# Review of egusphere-2025-379

## Extension of AVHRR-based climate data records: Exploring ways to simulate AVHRR radiances from Suomi-NPP VIIRS data

### Reviewer 1

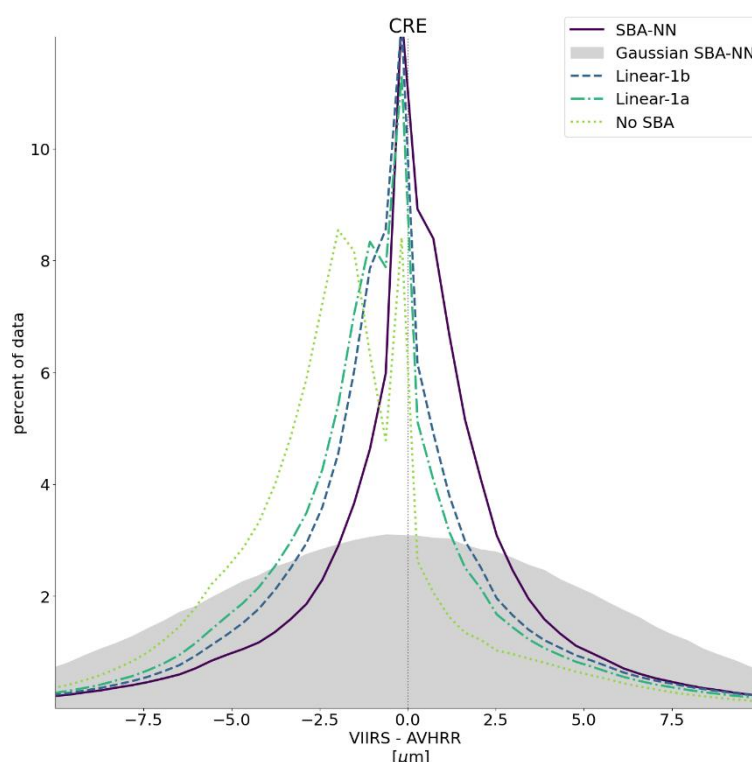
Figure 7, 8, 9

These figures present scatterplots of data pairs of cloud property retrieval from two different satellites. Although the authors did everything to collocate and synchronise the data pairs, much of the observed scatter is simply the result so collocation and synchronisation differences and does not talk so much about the performance of the SBAF correction. To mitigate this, it would be better to present the results are frequency distributions of differences as is done in Figure 6. Can the authors comment why they have chosen to use scatterplot instead of frequency distributions to present the results?

Author response: We decided to exclusively show frequency distributions in the same way as previously done for radiance comparisons in Figure6.

We give here an example for cloud effective radius (CRE) parameter:

With reference to the previous discussions and the introduction of the new category “No SBA”, it is clear that to use VIIRS radiances without corrections in the AVHRR processing environment leads to particular problems for the CRE parameter (dotted green line in the figure). This problem seems to be solved after applying the SBA-NN corrections.
